Joint Groundwater Experts Report

Land Court of Queensland

Report date: 9 January 2015

Figure 1. Groundwater Heads and Flow Directions in the Colinlea Sandstone [after Bleakley 2014⁴ and HydroSimulations 2014]

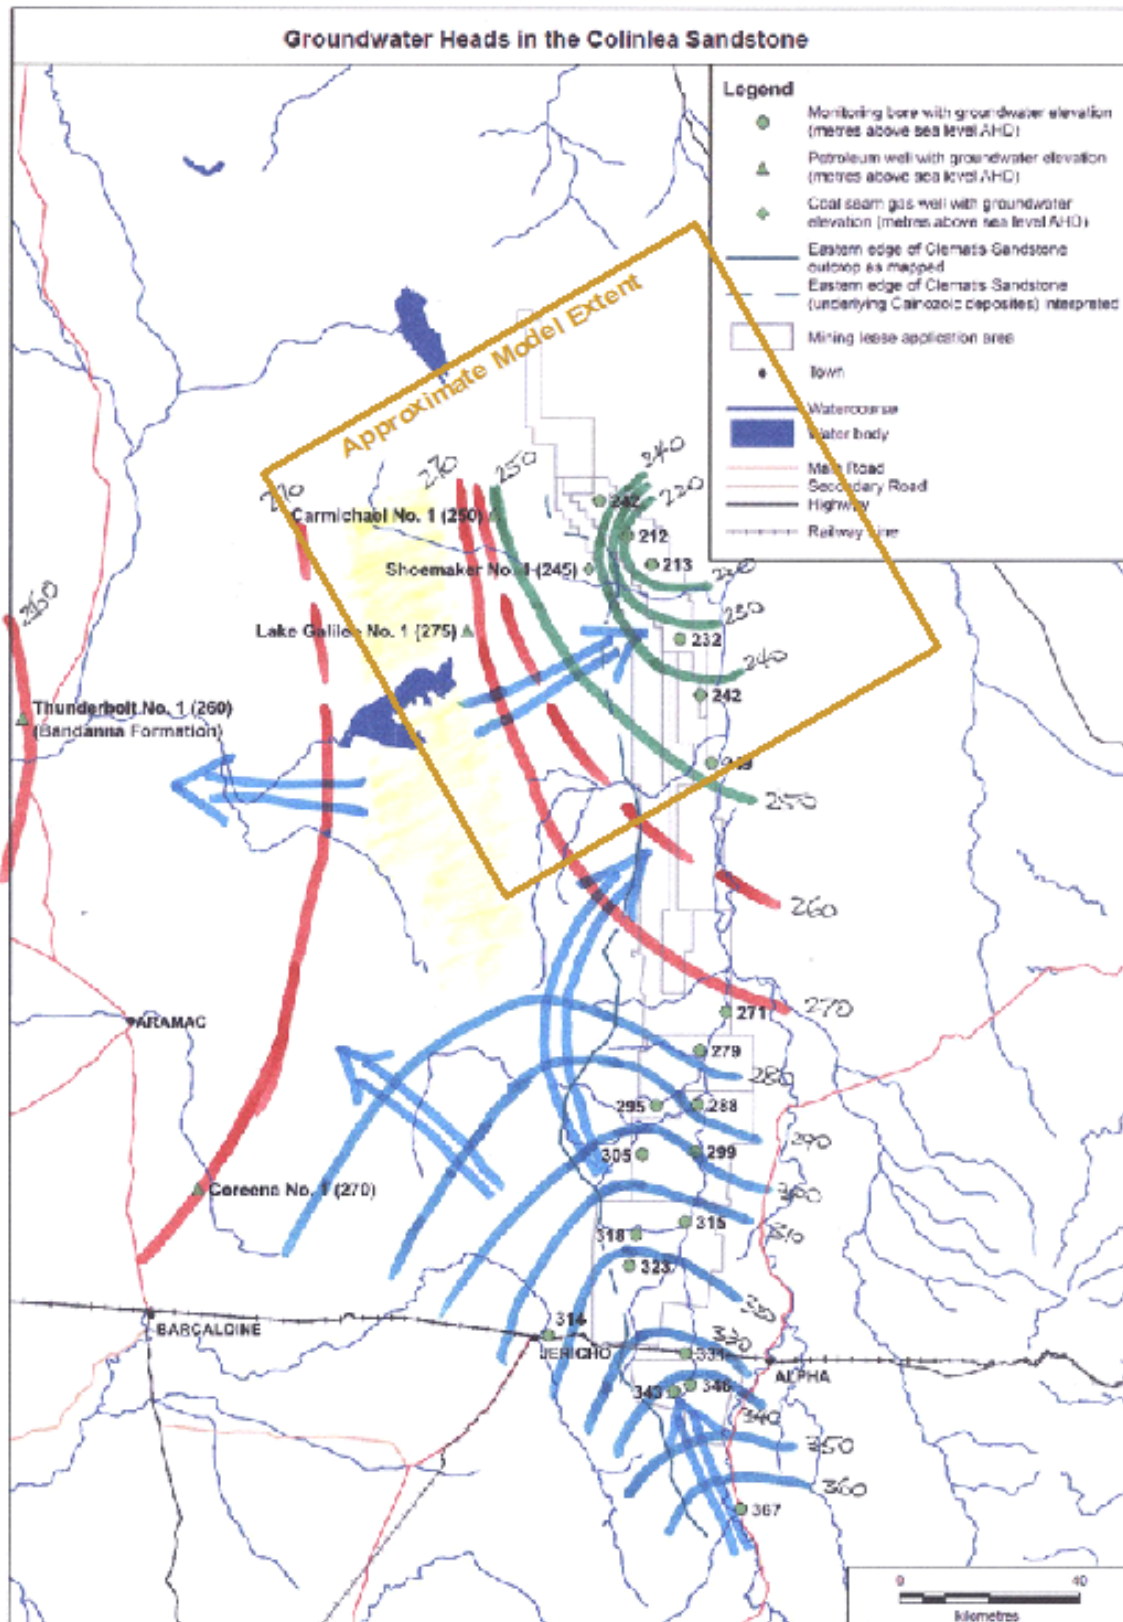
2. We agree that the flow directions as presented in the HydroSimulations report of 31 March 2014¹ are a reasonable best estimate of groundwater flow at depth (reproduced here as **Figure 1**).

3. We agree that the head contours for the Colinlea Sandstone suggest a groundwater divide which is offset (to the west) from the Doongmabulla Springs and is offset also from the groundwater divide presented in the conceptual model, which was the basis for the original numerical model.

Figure 2. Simulated Groundwater Heads (mAHd) for the Clematis Sandstone - Option 1 Scenario [after Figure 31 in GHD November 2014]

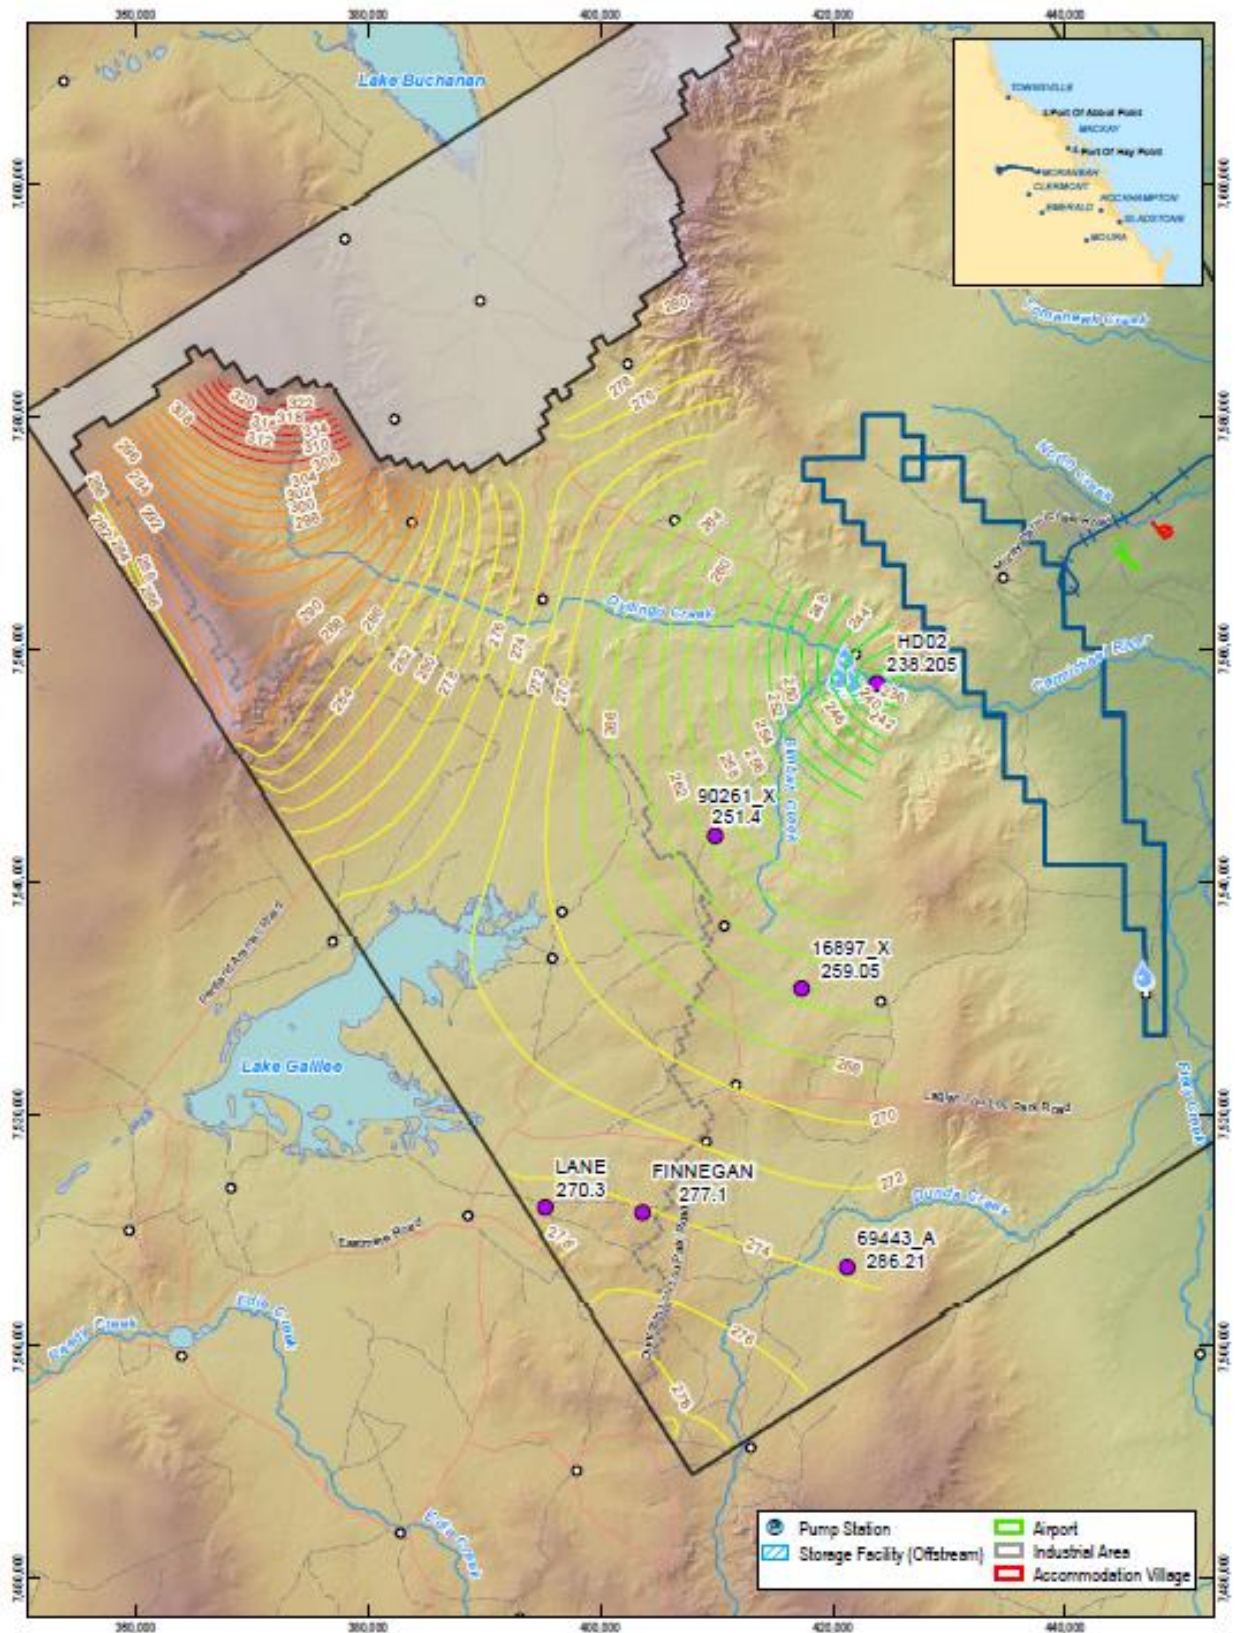
4. The contours shown for the Clematis Sandstone in the latest numerical model report (GHD, November 2014²; Figure 31 - reproduced here as **Figure 2**) suggest flow directions reasonably consistent with those in **Figure 1**, with the exception of areas in the north and northwest of the model domain.
